OFFICIAL TRANSCRIPT OF PROCEEDINGS

Agency: Nuclear Regulatory Commission  
Advisory Committee on Reactor Safeguards

Title: Subcommittee on Advanced  
Pressurized Water Reactors

DATE: Friday, November 3, 1989 PAGES: 1 - 231

**FIGURE 2.15  
WEDGE ANCHOR**

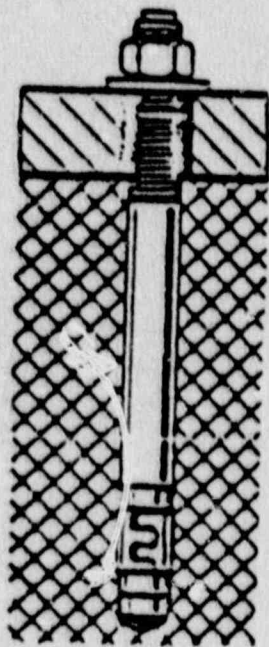
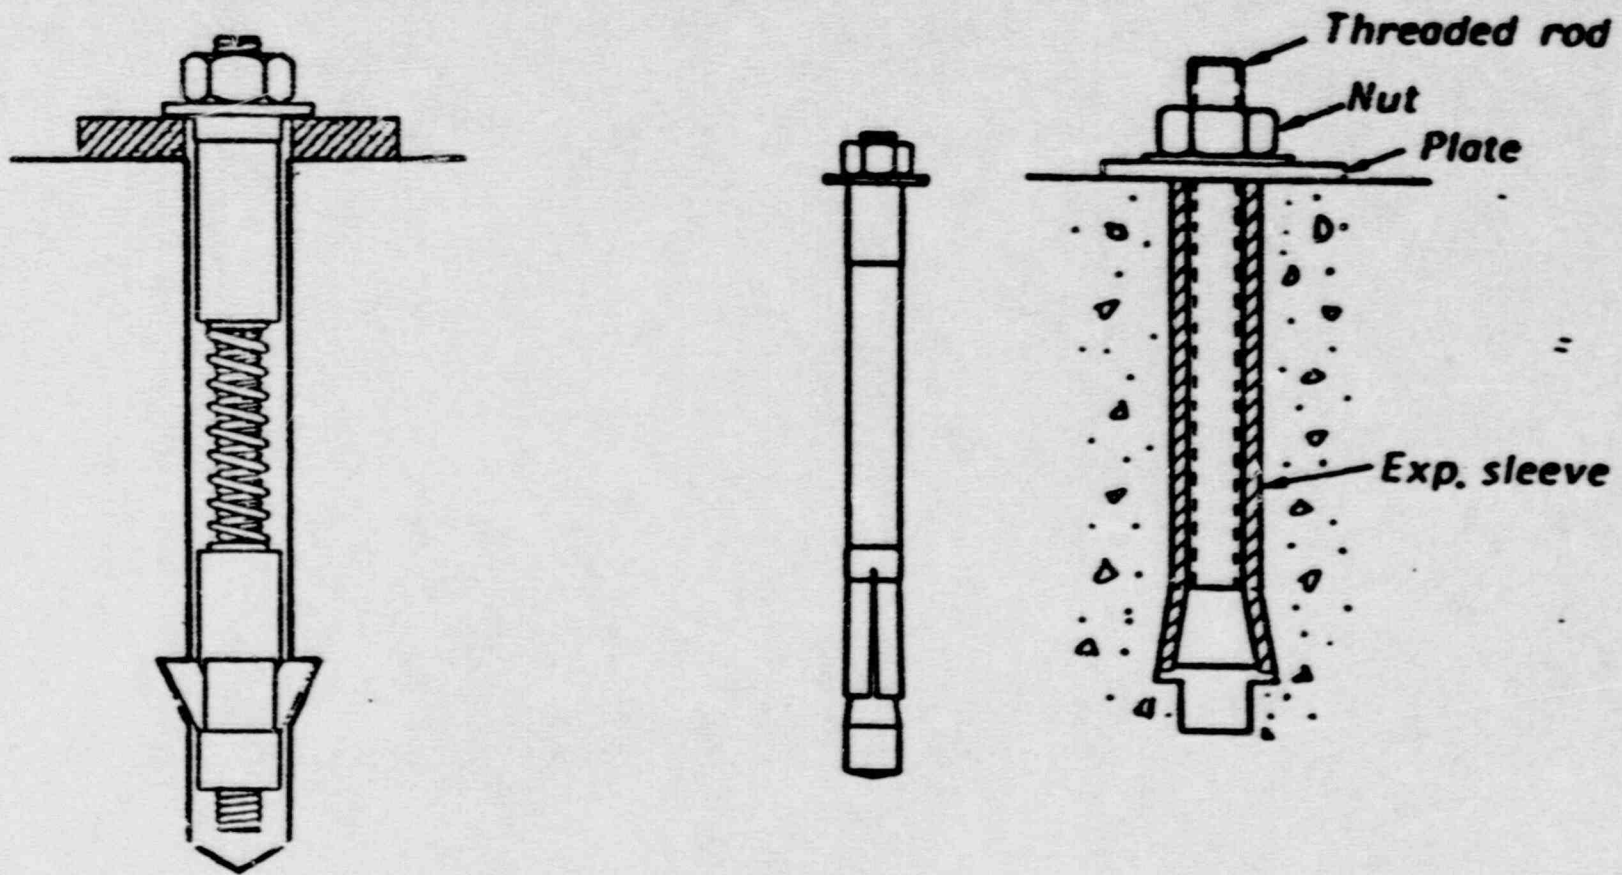
6 The open issue relates primarily to the  
7 implementation of IE Bulletin 7902 on expansion anchor bolts.  
8 That was issued back in 1979 and required that for nonductile  
9 expansion anchors and I'll show you what I mean by them.  
10 Specifically in the bulletin, they talk about wedge and sleeve  
11 anchors. They require a safety factor of 4 on SSE loads.

12 For those anchors, we have now committed to 79-02 and  
13 that was in some supplemental information that went into the  
14 staff in August, I believe. Since 7902 Bulletin came out,  
15 there has been considerable work in the industry and a new  
16 class of expansion anchors has been developed known as ductile  
17 expansion anchors that are undercut and again I'll show you in  
18 the next slide what I mean by that.

**WESTINGHOUSE POSITION**

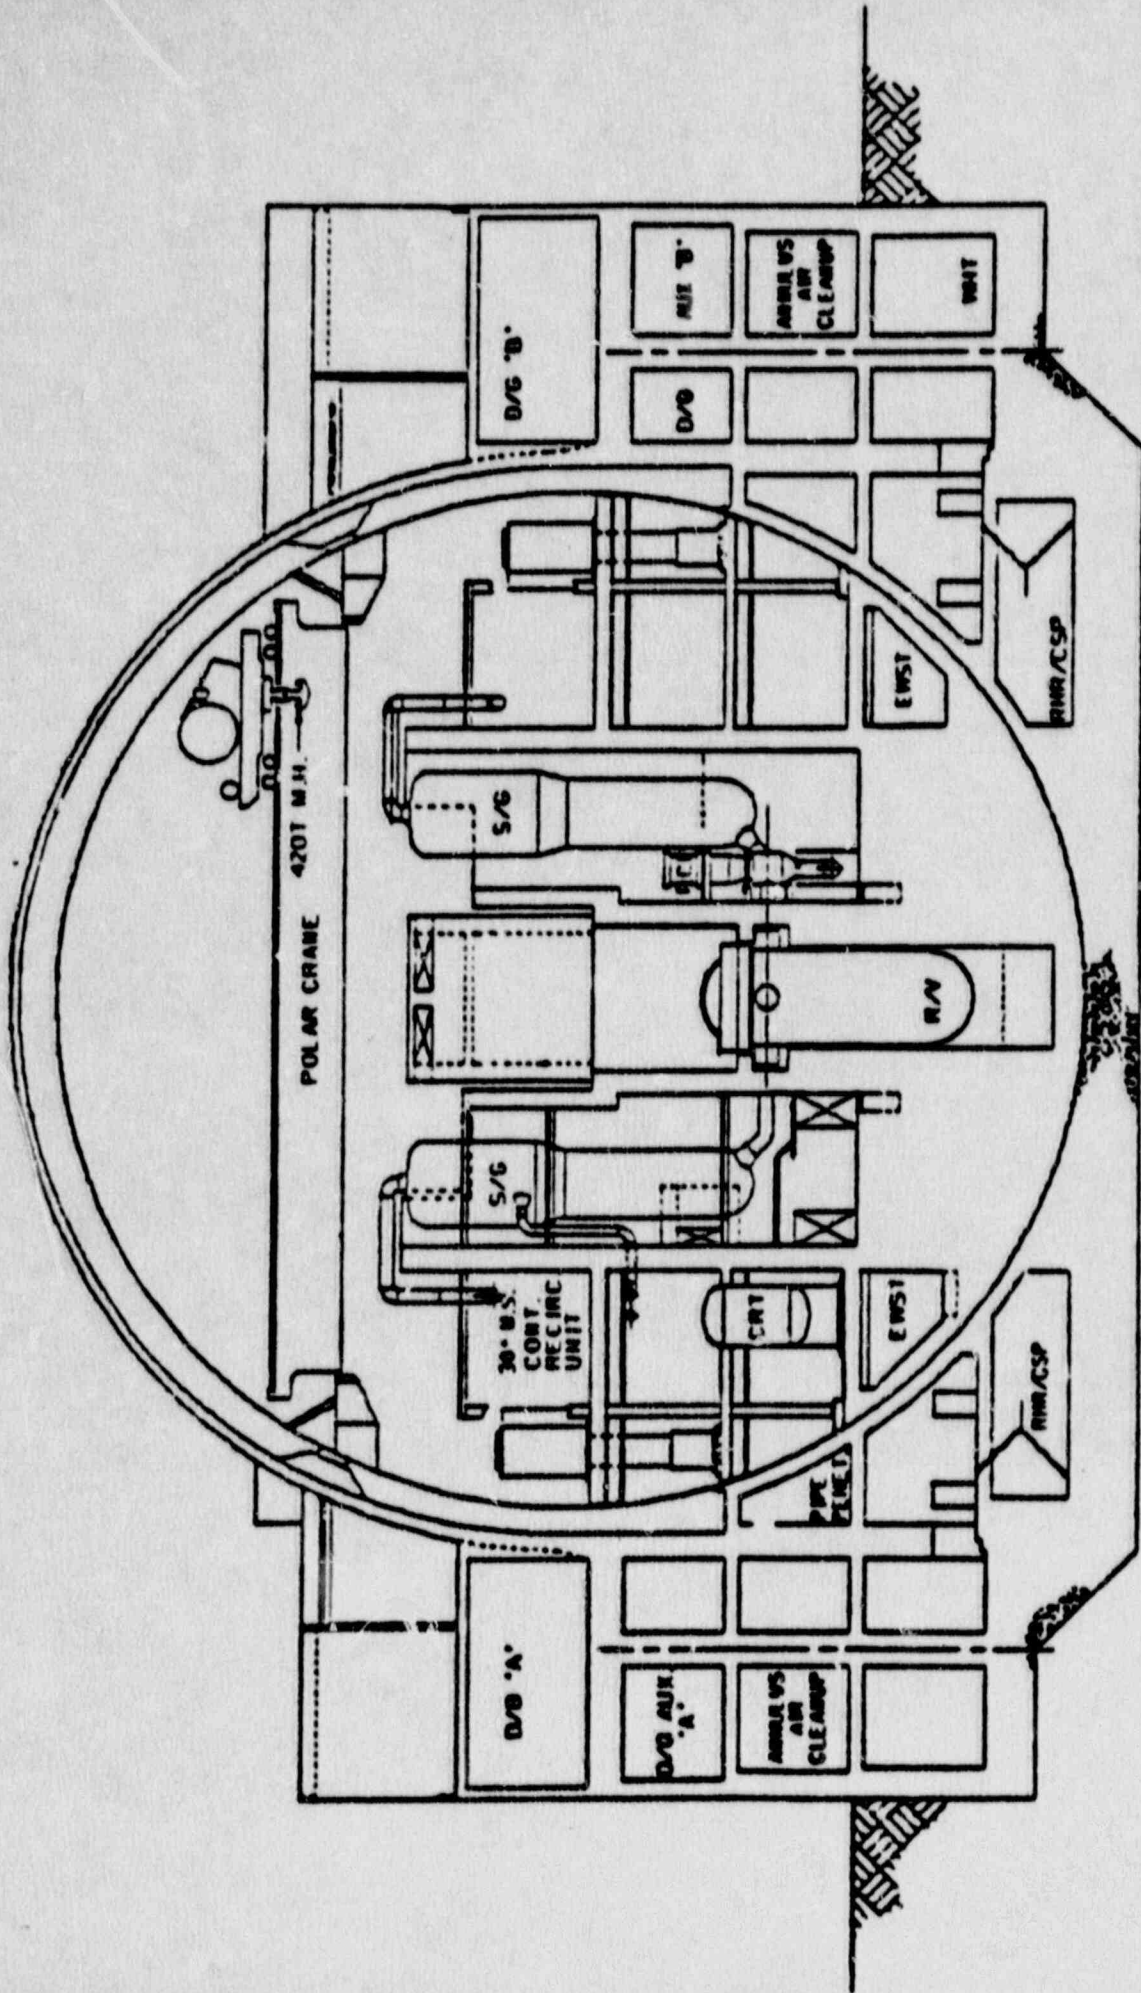
Westinghouse wish to use the latest industry standard for seismic analysis since it provides a comprehensive set of requirements.

NRC staff have no resources assigned to determining generic positions on new or revised codes and standards and continue to review changes on a case by case basis. In many cases this means that they use positions that are not consistent with the latest codes.

## MID-LOOP OPERATION\*

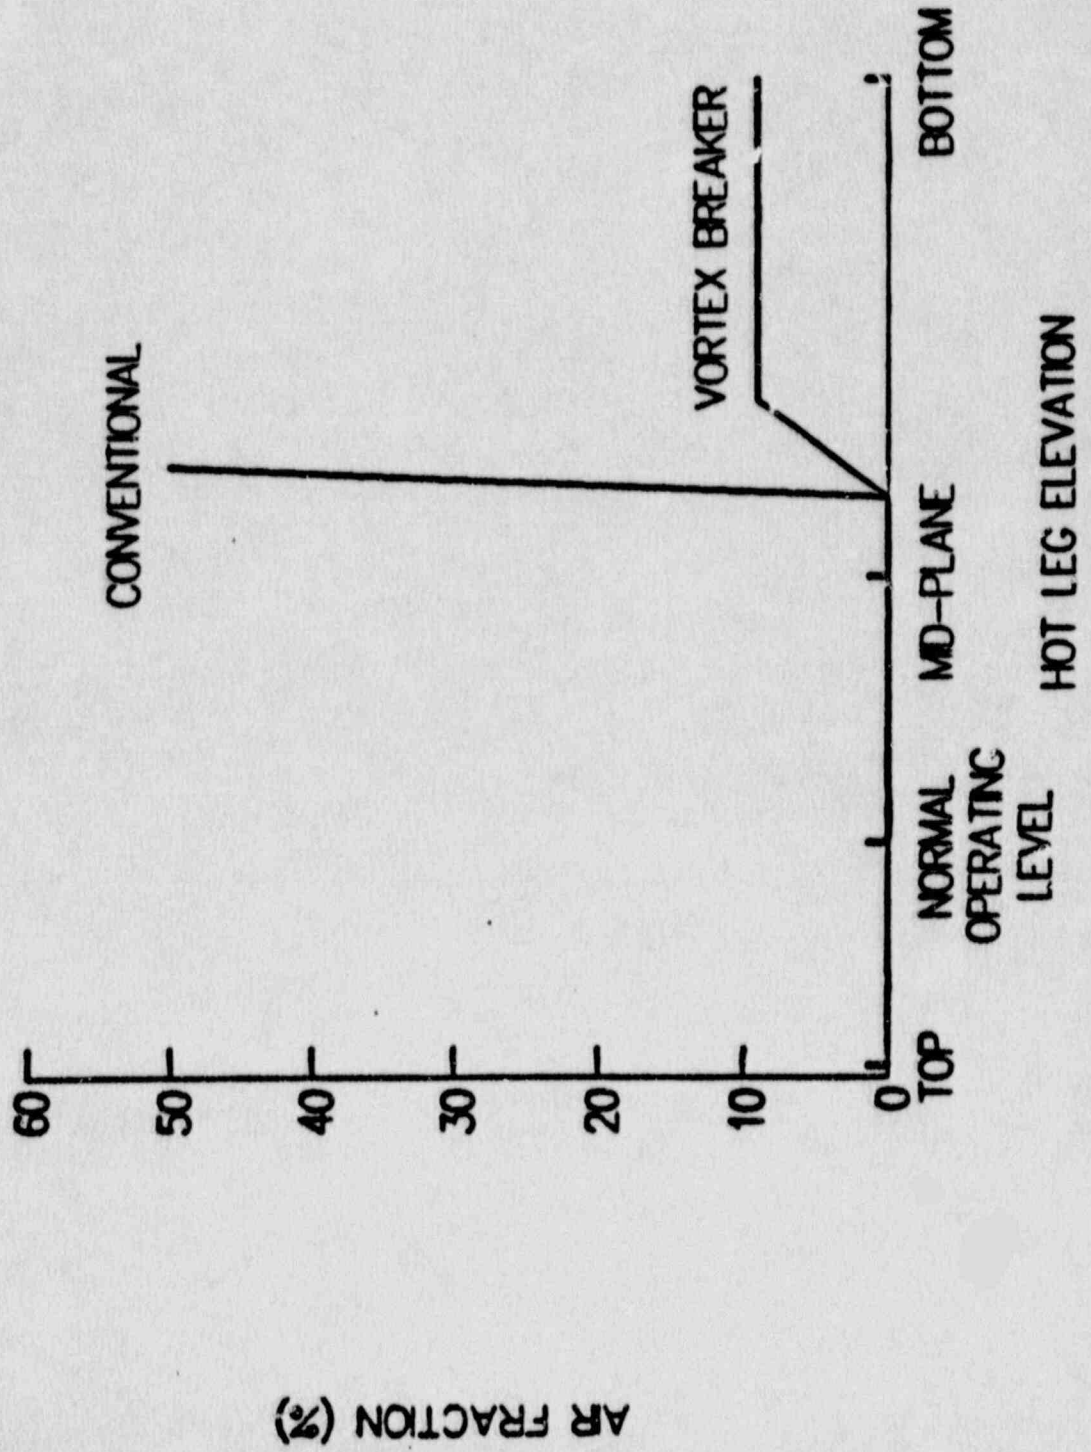
- WATER LEVEL DURING MID-LOOP OPERATION IS AT LEAST 9 INCHES ABOVE ACTUAL MID-PLANE ELEVATION.
- WITH VORTEX BREAKER, AIR ENTRAINMENT STARTS TO OCCUR AT APPROXIMATELY 3 INCHES BELOW MID-PLANE ELEVATION, BUT IS LIMITED TO LESS THAN 10%.
- RHR SUCTION LINES ARE SLOPED CONTINUOUSLY DOWNWARDS TOWARDS RHR PUMPS AND ARE, THEREFORE, SELF-VENTING.
- RHR PUMP SUCTION LINES PROVIDE ADEQUATE PUMP NPSH AT FULL FLOW ASSUMING SATURATION IN THE HOT LEG.
- HHSI PUMP WILL BE AVAILABLE DURING MID-LOOP OPERATION FOR EMERGENCY MAKEUP IF REQUIRED.

\* DSER OPEN ISSUE 54

# HOT LEG RHR CONNECTION

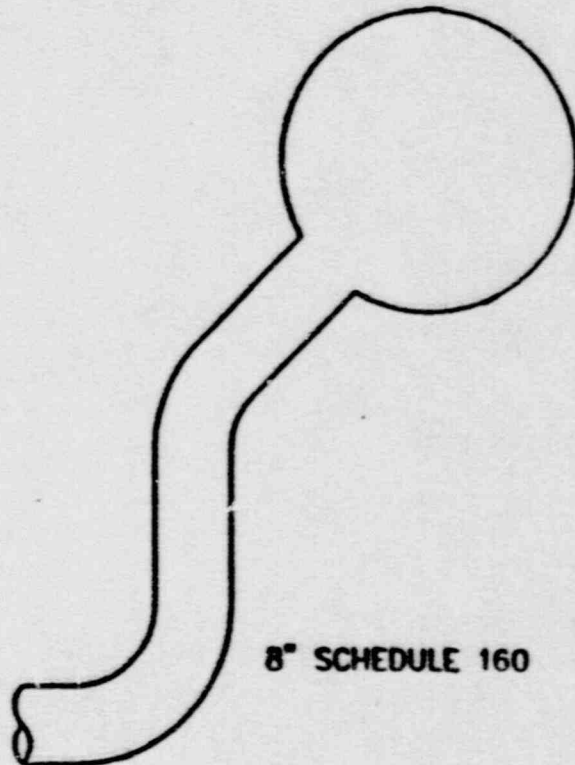
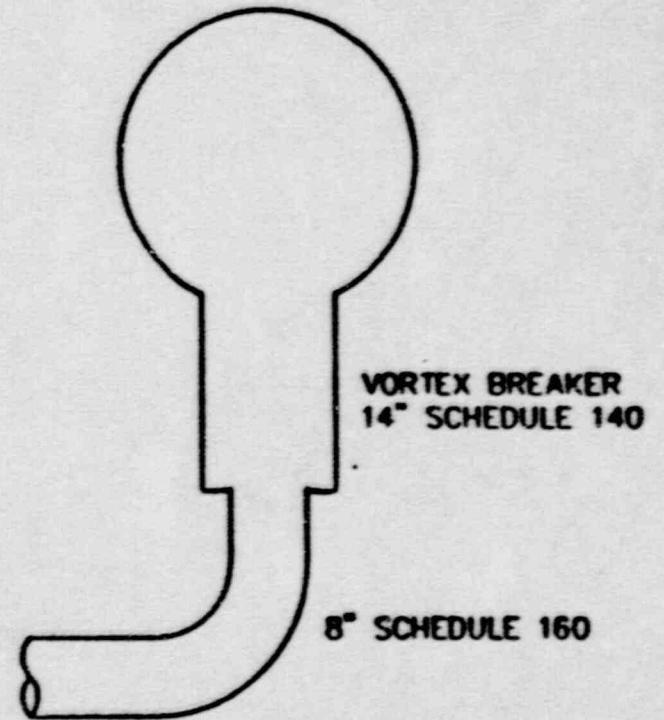
PRESENT SP/90

PDA COMMITMENT

#### RESAR-SP/90 RESOLUTION APPROACH

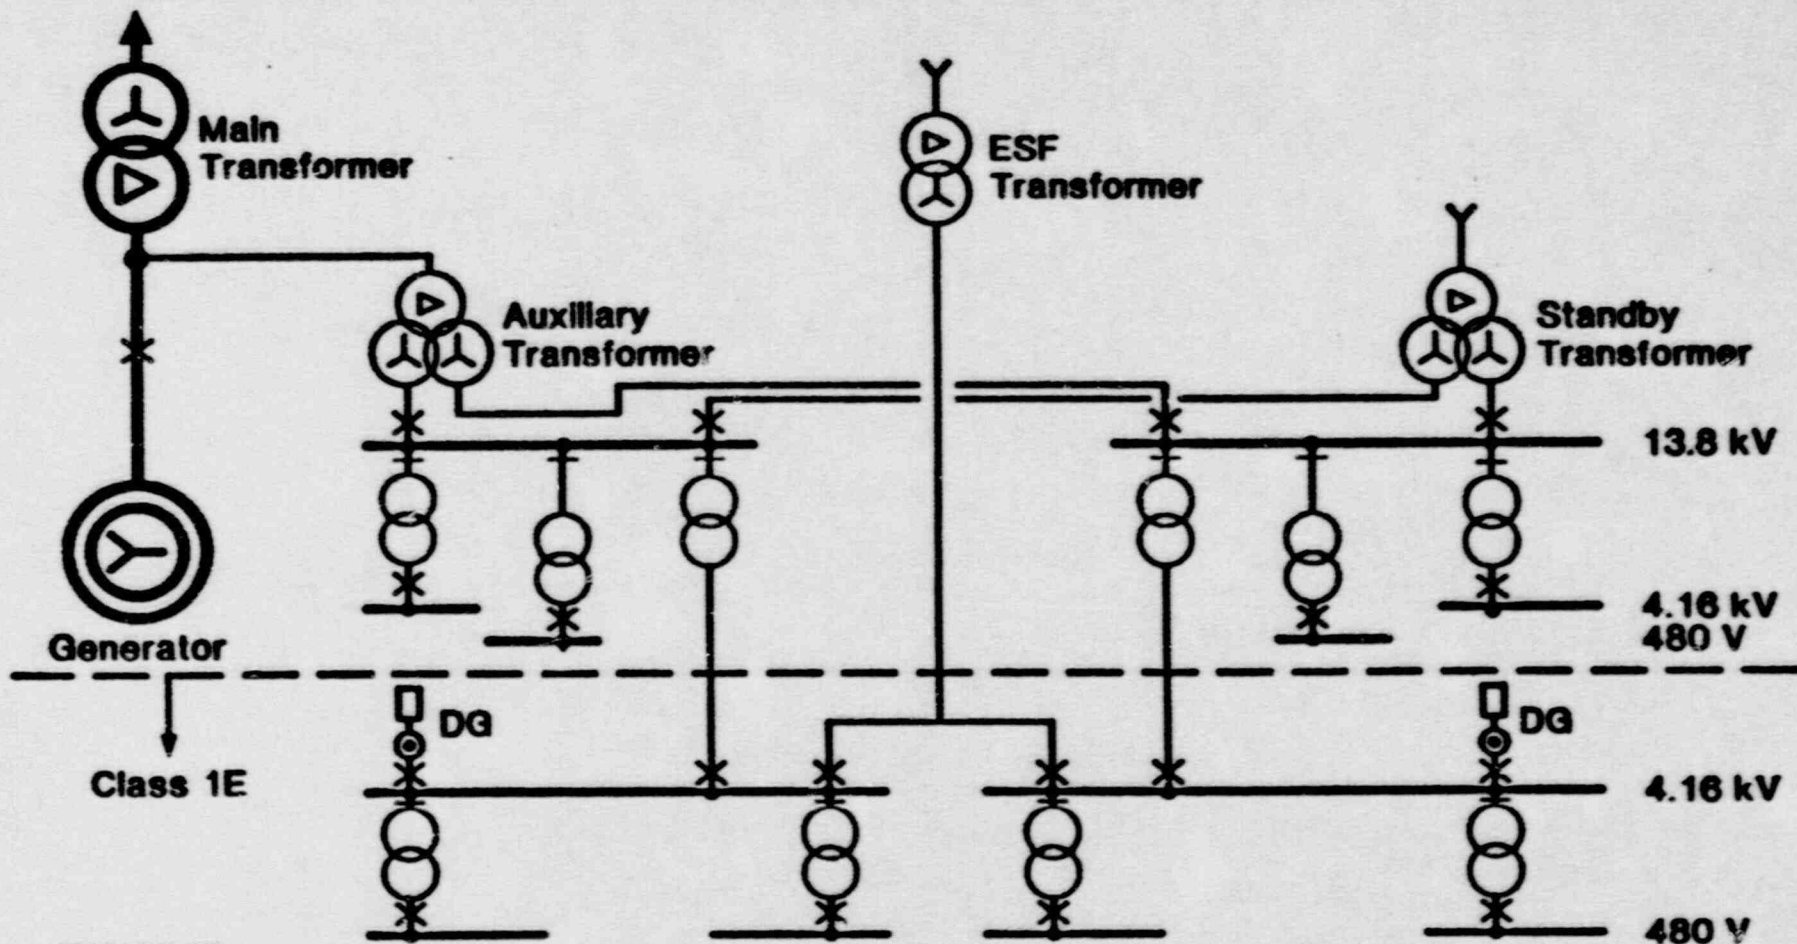
Westinghouse considers the hydrogen igniters to be an acceptable backup to the hydrogen recombiners in accordance with the intent of R.G. 1.7. However, if this approach is not acceptable to the staff, Westinghouse will commit to design the operating purge system in accordance with the requirements of R.G. 1.7 in order to aid in cleanup following a LOCA.

The "hardened" venting capability is related to the "Severe Accident Issue" on containment performance. This issue is presently considered by the staff as part of their review of the EPRI ALWR Requirements Document, which incorporates the Nuclear Industry (including Westinghouse) position that such a vent is not required. Westinghouse commits to meet any new requirements that may be forthcoming from this review in the FDA submittal.
